CITY OF
West Linn
 PLANNING AND DEVELOPMENT

PLANNING DIRECTOR DECISION

FILE NO.: MISC-12-16

REQUEST: Request for a Flood Management Area (FMA) permit for additions to an existing house at 5650 River Street

Figure 3: Flood boundaries

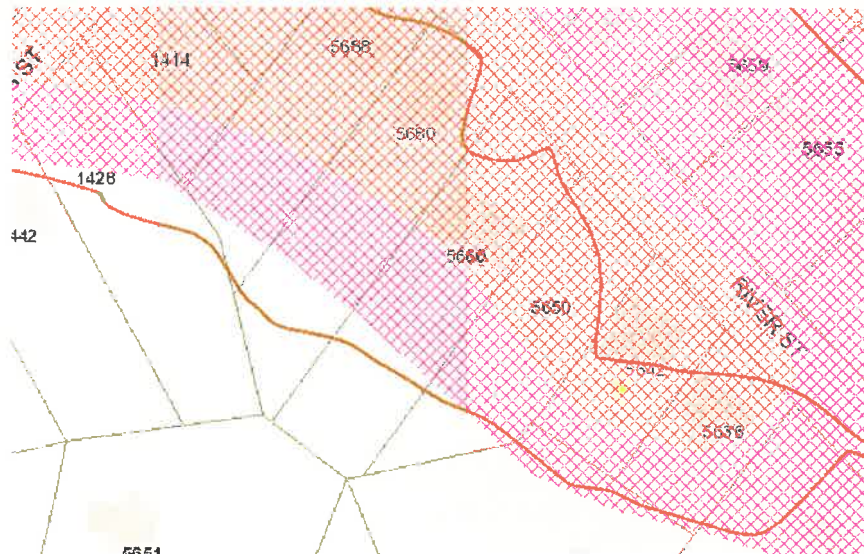
(Staff notes that there is a map calibration issue with both the USACE/FEMA maps and the City's mapping in that they show 100 year flood waters (orange) inundating River Street and then extending half way downhill on the subject property. The maps should show the 100 year flood boundaries about 60 feet to the southwest in the low ground generally overlapping the 1996 flood delineation (brown line).)
